# MBHP\_OPL3 module modifications, the 5V option

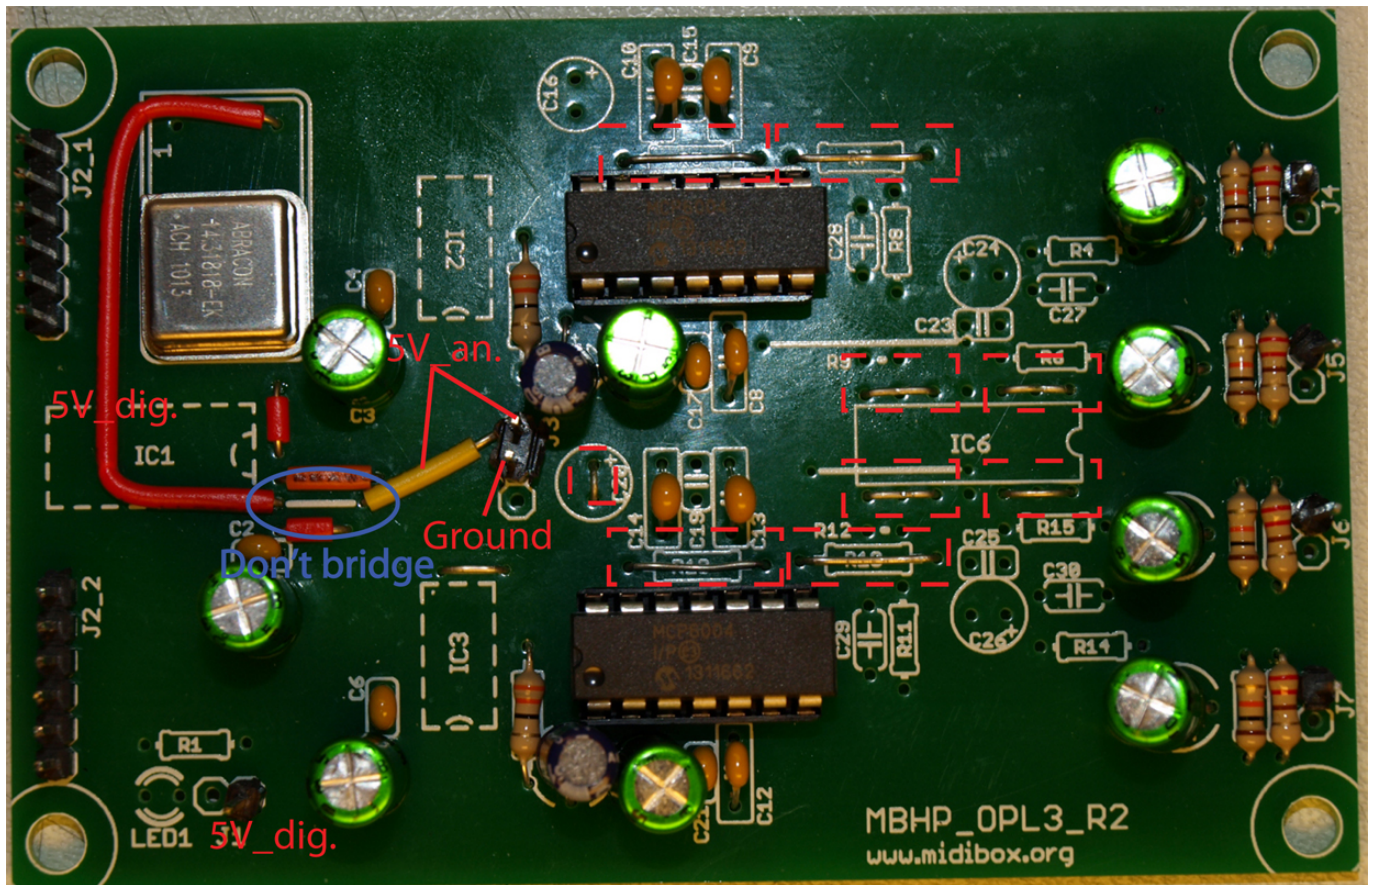
- Replace R5,R7,R10 and R13 with jumpers
- Bridge IC6 pads 1&3, 5&7, 8&10 and 12&14
- Leave out:  
IC6  
R4, R6, R8, R9, R11, R12, R14, R15  
C15, C16, C19, C20, C23-C30
- Bridge C20 pads (to supply Ground for the op-amps)
- Leave out bridges to IC6
- Use MCP6004 for IC3 and IC5
- Supply 5V to the +12V pin, and Ground to Ground

This way the second buffering stage is left out.

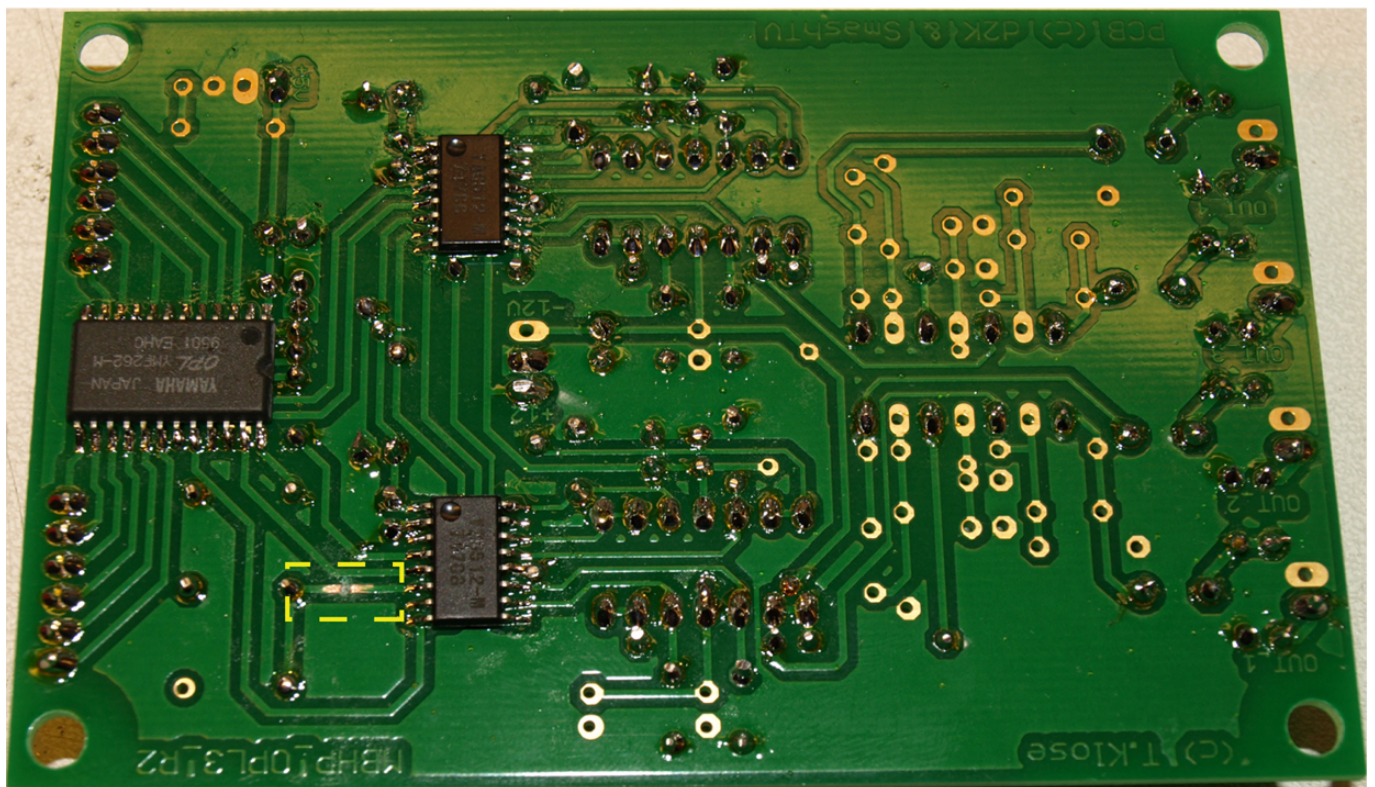
- Cut the trace between the 5V pin of the Oscillator and the DAC
- Leave out the middle horizontal bridge from IC1
- Connect the right pad of this bridge to the 5V pin in the middle of the board with a jumper
- Connect the left pad of this bridge to the 5V pin of the Oscillator with a jumper

Bridge

Cut trace
